Addendum 3 for RFB928300-01

Project Name: CHMHI Voldeng Building Remodel
DAS RFB #: 928300-01
DAS Project #: 9283.00
Date: 11/30/2023

C301

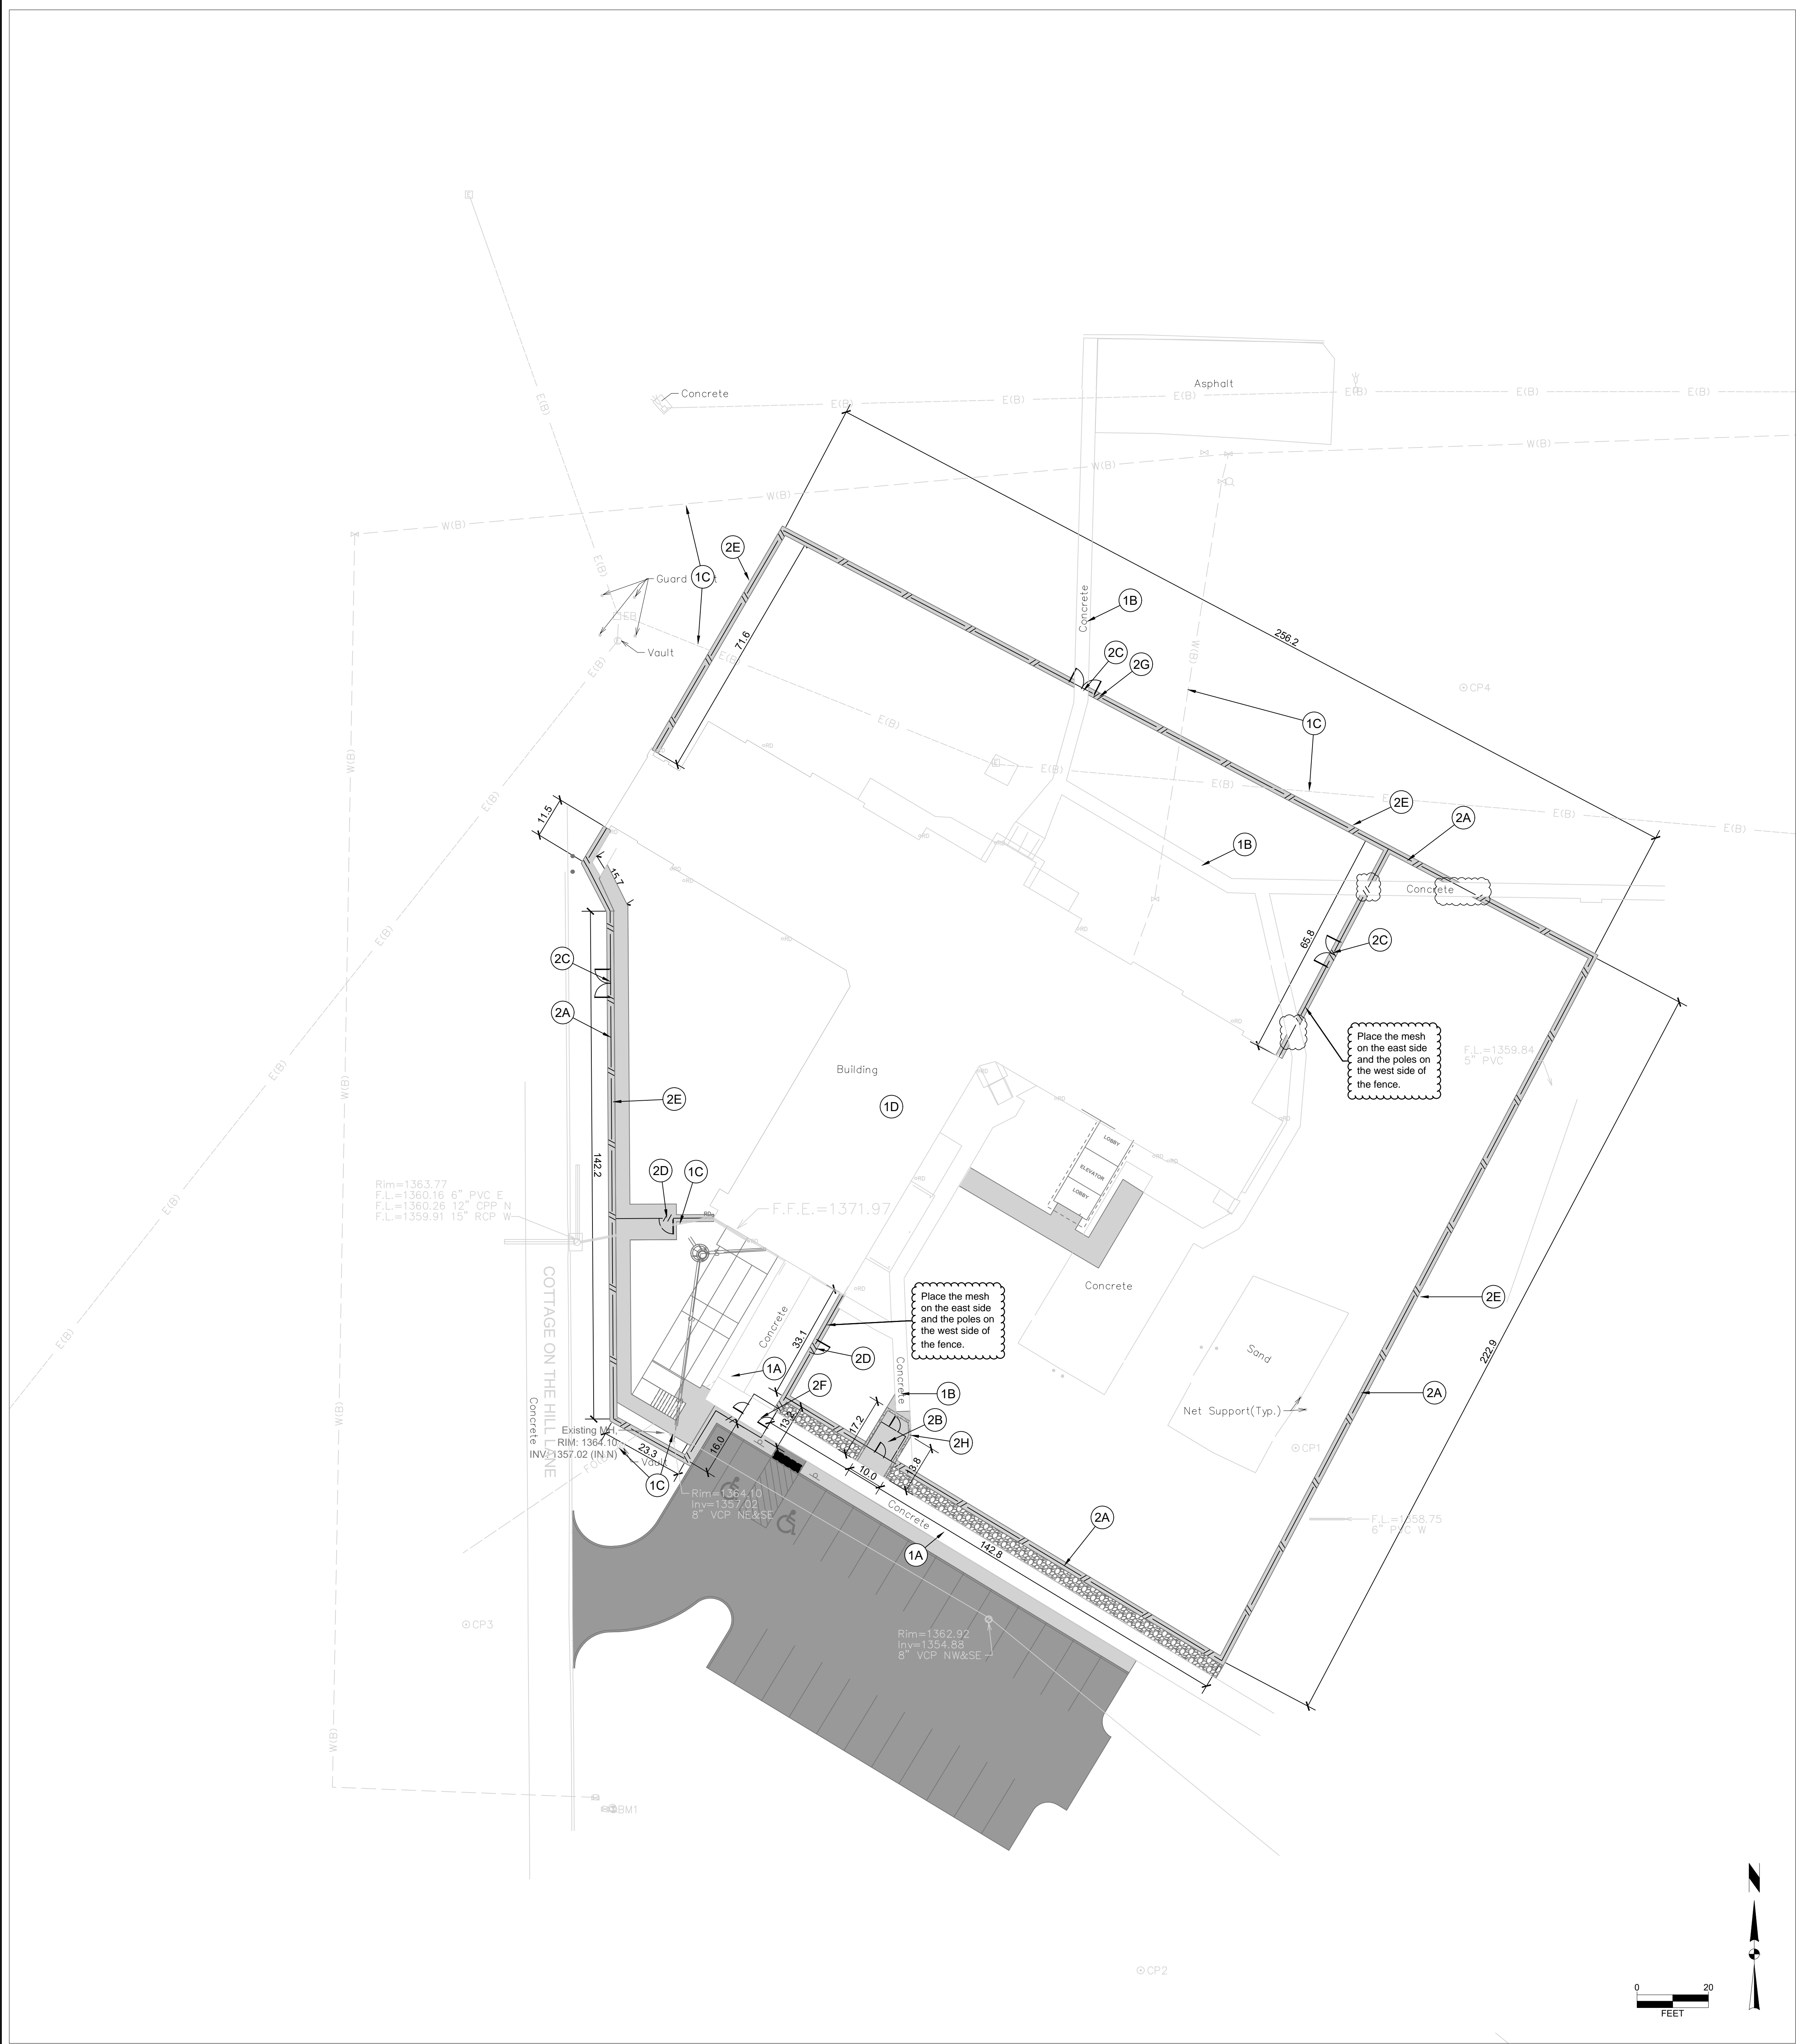
- A2. That note should have said 'SEE SHEETS S100 AND S101'.
- Q3. On sheet C301 typical fence is shown with the correct height, on the typical double gate the height is 4.15' and 4.0', and on typical single gate the height is 8' and 4.0', could you please clarify?

- The height of the fence at the double gate should be 12'-0" and 4'-0" and the height at the single gate should be 12'-0" and 4'-0". See the updated drawing that is attached as part of this addendum.

- A3. On both details, the fence height should be 12'-0" and 4'-0". This has been updated on the revised C301 sheet that is part of this addendum.
- Q4. In the stairs throughout the building there are railings and handrails, are these to be painted?
